TOWN OF PALM BEACH
Planning, Zoning & Building Department
360 South County Road
Palm Beach, FL 33480
www.townofpalmbeach.com

PZ&B Staff Combination Memorandum: Landmarks Preservation Commission and Town Council

SUBJECT: ZON-24-0065 (COA-24-0025) 70 MIDDLE RD (COMBO)

MEETING: APRIL 16, 2025 LPC
MAY 14, 2025 TC

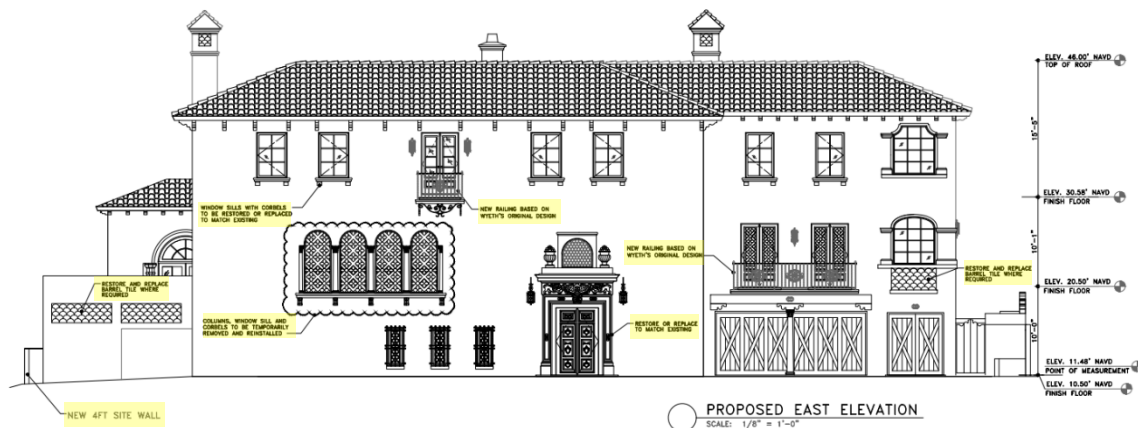
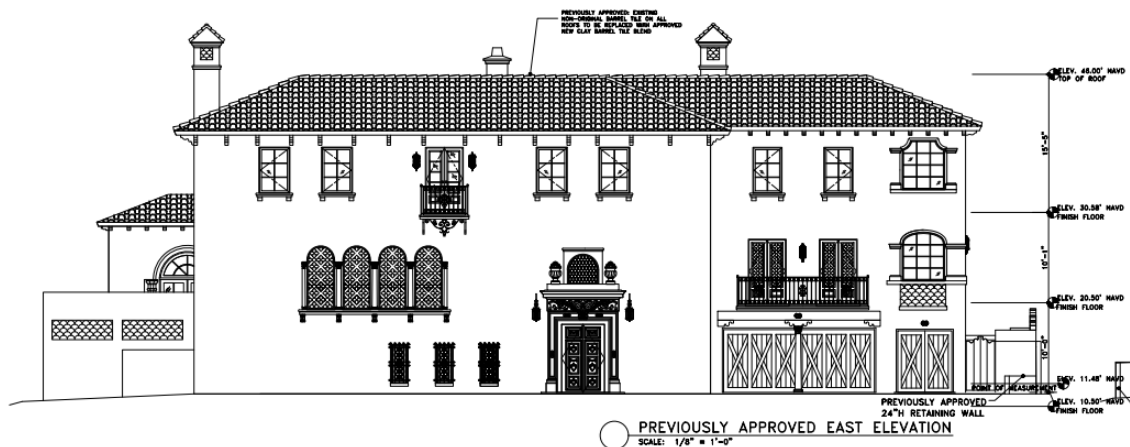
The previously approved COA included a covered terrace and laundry room addition on the north side of the property. These improvements required variances which did not proceed to Town Council for approval, as outlined in the History section of this memorandum.

The covered terrace is proposed over an existing flat roof, and the laundry room addition extends the space approximately 7'-4 3/4" to the north. Both additions are designed with new clay barrel tiles roofs to match existing, as well as exterior finishes and detailing that are consistent with the landmarked property.

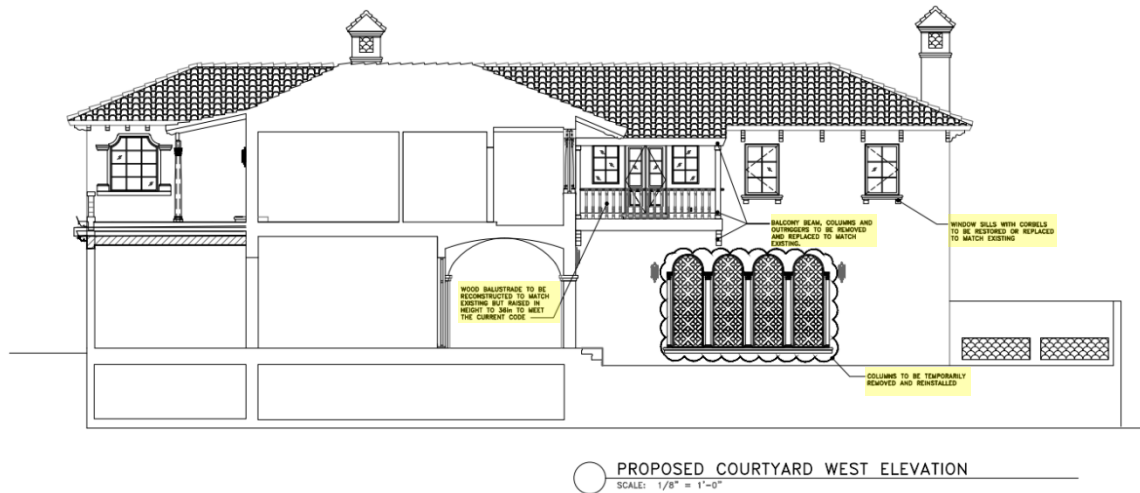
On the east elevation, the existing columns and window sills adjacent to arched stained-glass windows will be temporarily removed and reinstalled. The window sills and front door surround are also proposed to be restored or replaced to match existing. Impact glass has been previously approved to be installed in front of the stained glass, under an administratively reviewed application. Barrel tile detailing on the east elevation will be restored or replaced. Additionally, the balcony railings will be replaced to match Wyeth's original design.

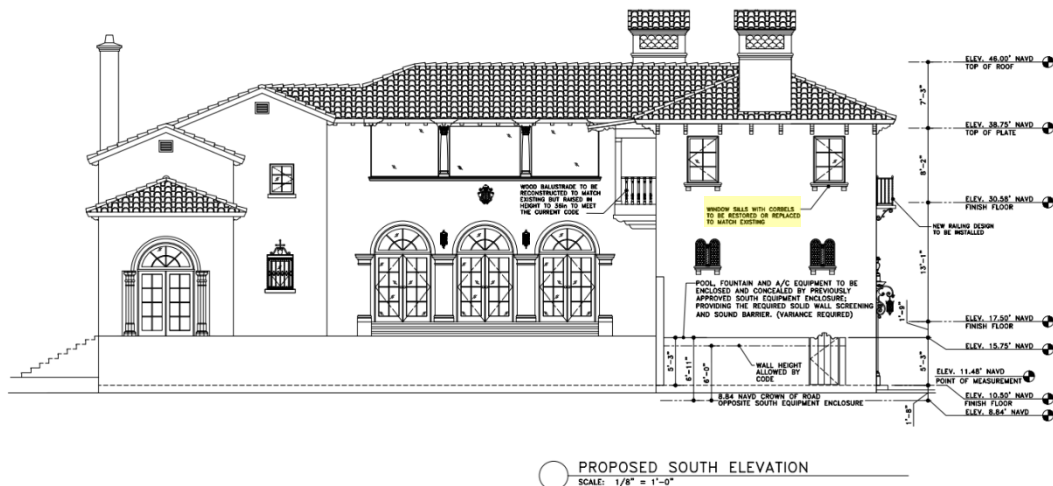
On the west courtyard section, the same treatment for the columns adjacent to the arched stained glass windows is proposed. The balcony balustrade, beam, column, and outriggers are proposed to be replaced to match existing. Additionally, window sills are proposed to be restored or replaced to match the existing.

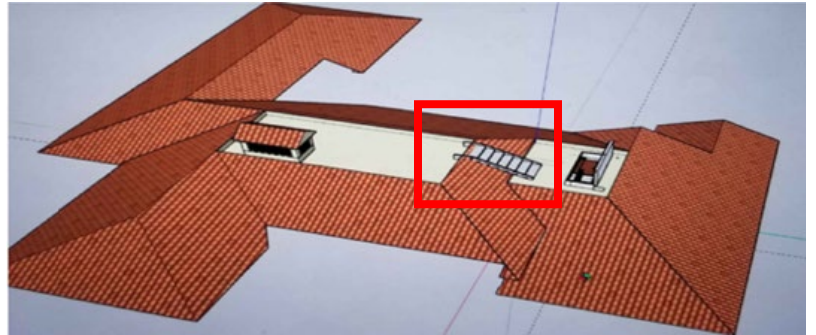
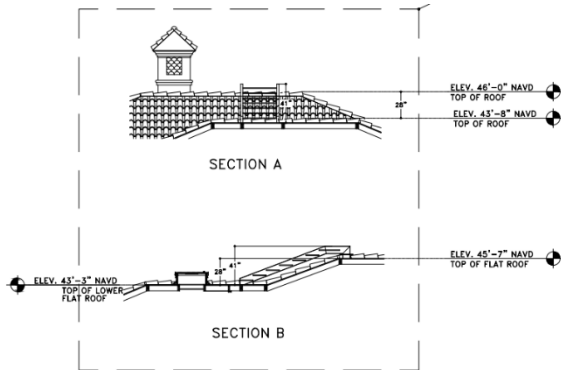
On the south elevation, the window sills are proposed to be restored or replaced to match existing.

The scope of work includes new rooftop aluminum steps. According to the applicant, the steps are needed to ensure the safety of the maintenance crew. Since the height of the landmarked structure is non-conforming, the installation of the new steps requires a variance, which is further discussed in the variance analysis portion of this memorandum.

ORIGINAL VAULTED LOGGIA TERRACE EXTENDING INTO COURTYARD (AS PER MARION SIMS WYETH c.1924)

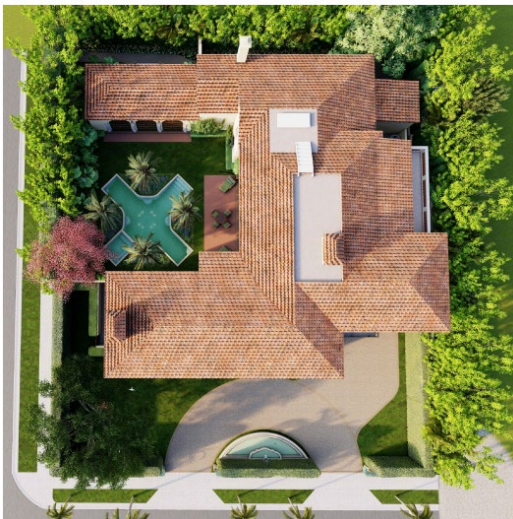
Hexagon terracotta tiles are proposed for the loggia landing and terrace, inspired by historic photographs.

NORTH ELEVATION

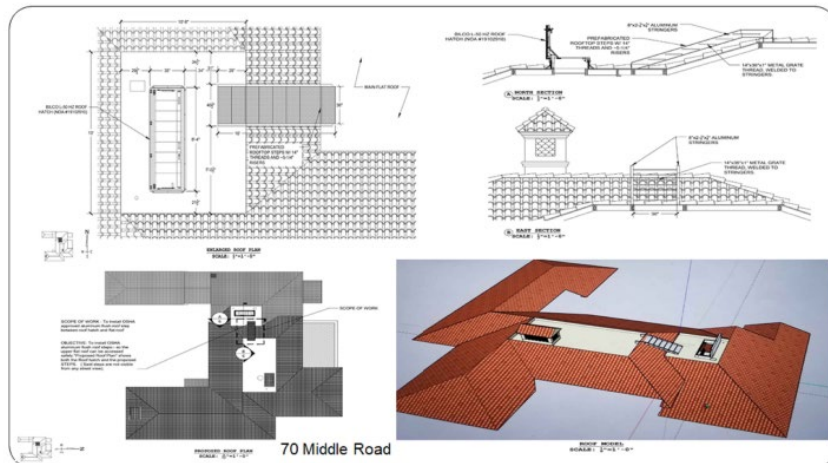
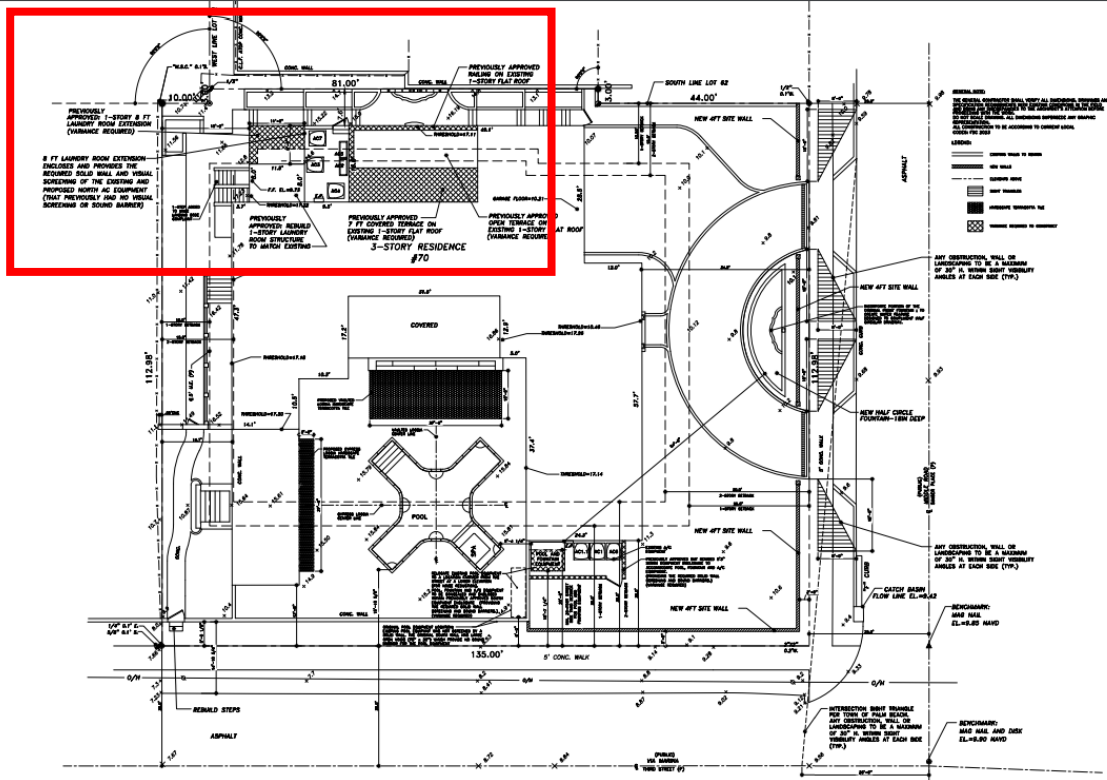
- **Variance #1** increases the lot coverage for the laundry room addition to 34.07%, exceeding the existing 33.47%, and the 30% maximum allowed.
- **Variance #2** increases the cubic content ratio (CCR) to 8.59 for the laundry room and covered terrace additions, compared to the existing 8.44 and the maximum permitted 3.95. **Variance #3** reduces the side (north) yard setback for the laundry room and covered terrace additions to 7.6', rather than the required minimum of 12.5'. A portion of the structure already projects to a 7.6' setback on the north side of the property.
- **Variance #4** increases the building height of the covered terrace addition to 27.4', surpassing the 22' maximum allowed, as well as increasing the rooftop steps to 47.1', exceeding both the existing overall building height of 46' and the 30' maximum permitted.

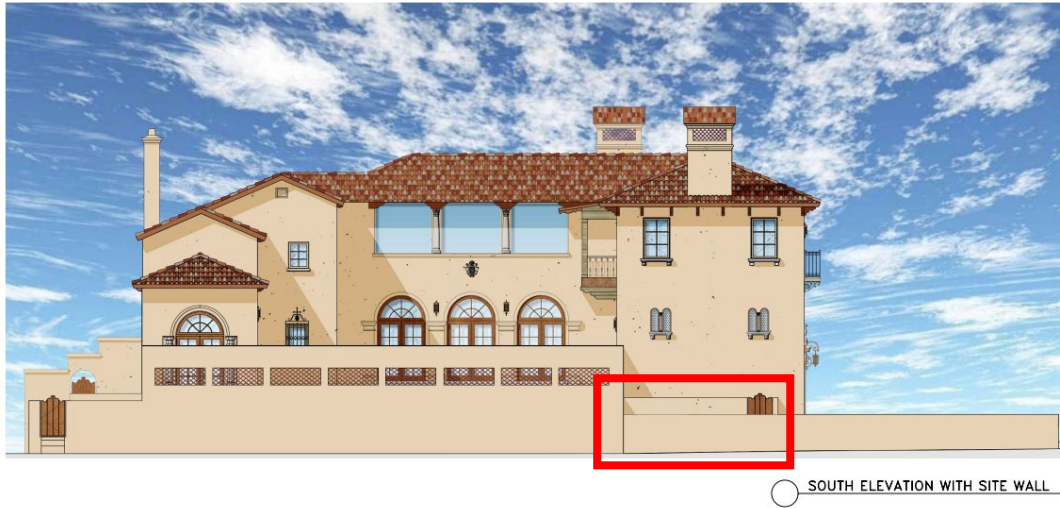
- **Variance #5** reduces the street (south) side yard setback for the pool and fountain equipment to 15.6', rather than the required 20', while also increasing the allowable distance between the new fountain's water edge and the fountain equipment to 54.5', beyond the 25' maximum permitted.
- **Variance #6** increases the height of site walls associated with a mechanical equipment enclosure in the street (south) side yard setback to 6.9', exceeding the allowed maximum of 6'
